Access Compliance Report

Public Rights-of-Way

(Curb Ramps)

Intersection ID: 25272	Main Street: BRIDLE_BROOK_WY	Cross Street: MAYNARD_RD	Location: W
ADA ID: 9DD322B450F7	Ramp Type: Perp	Initial Pass/Fail: Fail	Overall Compliance: No
Severity Score: 37.5			
Codes/Mitigation Info/Possible Solution		Field Measurements/Component Compliance

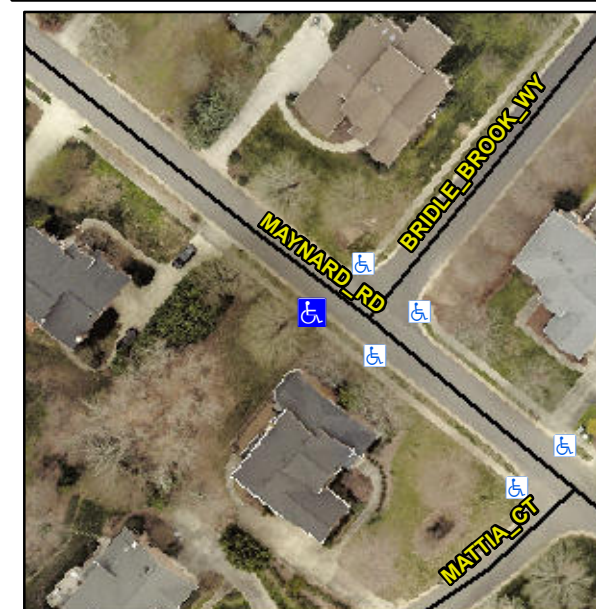
Not Found, R304.2.2, R304.5.3

Compliance	Description	Data	Compliance	Description	Data
N/A	Ramp Length (in)	51.0	No	Ramp Slope (%)	13.6
Yes	Ramp Width (in)	49.0	No	Ramp XSlope (%)	6.5
N/A	Flare Type LT	N/A	N/A	Flare Type RT	N/A
N/A	Flare Slope LT (%)	N/A	N/A	Flare Slope RT (%)	N/A
N/A	Flare Traversable LT?	N/A	N/A	Flare Traversable RT?	N/A
N/A	Landing Length (in)	N/A	N/A	DWS Provided?	N/A
N/A	Landing Width (in)	N/A	N/A	DWS Contrast?	N/A
N/A	Landing Slope (%)	N/A	N/A	DWS Length (in)	N/A
N/A	Landing X Slope (%)	N/A	N/A	DWS Full Width?	N/A
N/A	Landing Curb? (Y/N)	N/A	N/A	DWS Offset (in)	N/A
N/A	Shared Landing?	N/A			
N/A	Gutter Ponding?	N/A	N/A	Gutter Slope (%)	N/A
N/A	Gutter Lip Ht (in)	N/A	N/A	Gutter X Slope (%)	N/A
N/A	Painted X Walk1?	No	N/A	Painted X Walk2?	N/A
	X Walk 1 Direction	To NE		X Walk 2 Direction	N/A
N/A	X Walk 1 Width (in)	N/A	N/A	X Walk 2 Width (in)	N/A
	X Walk 1 Slope (%)	0.6		X Walk 2 Slope (%)	N/A
	X Walk 1 X Slope (%)	6.9		X Walk 2 X Slope (%)	N/A

Remove & Replace Entire Ramp.
